## Release Notes for MPiec controller firmware

### Release 2.6.3 build 1

#### Patch for MP2300Siec and MP2310iec only

Released June 16, 2015.

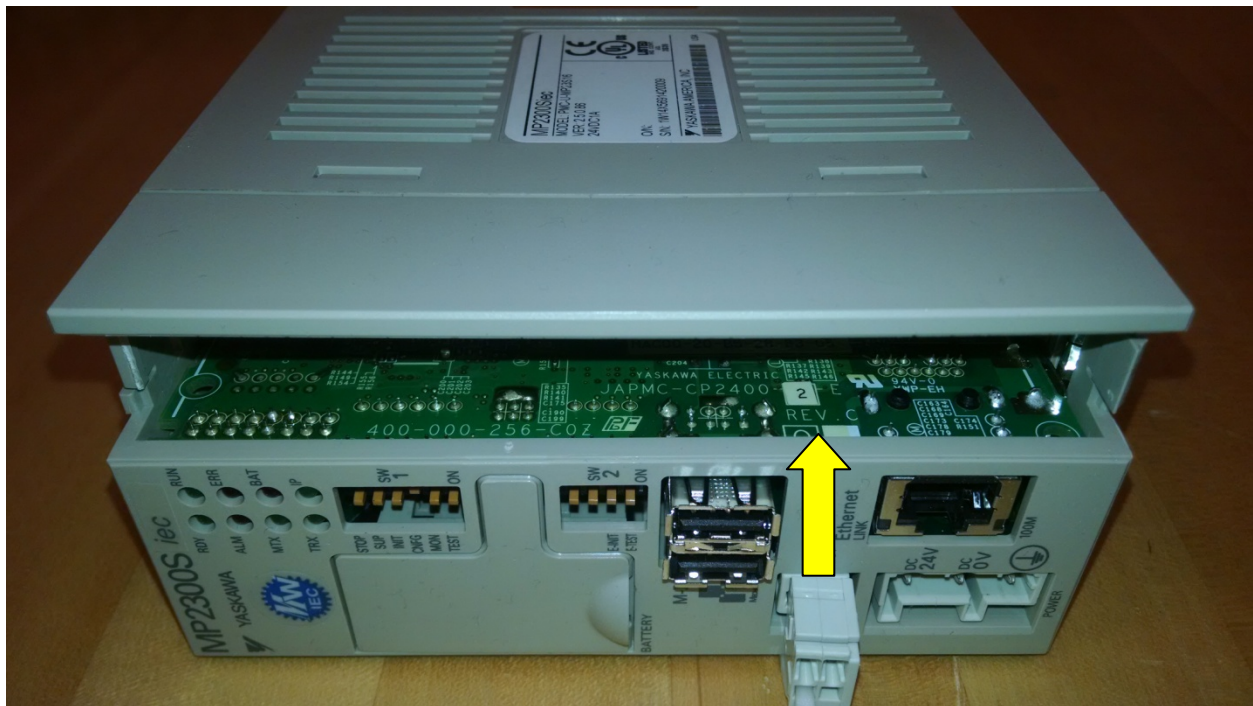
2.6.3.1 is a special release for the MP2300Siec and MP2310iec controllers with rev C hardware. To determine if the controller has rev C hardware, look at the silkscreen of the CPU board as shown below. If your machine was designed and tested using firmware 2.6.x firmware, Yaskawa recommends updating to this version as the only difference is a change to eliminate the chance for impaired Ethernet performance as noted below.
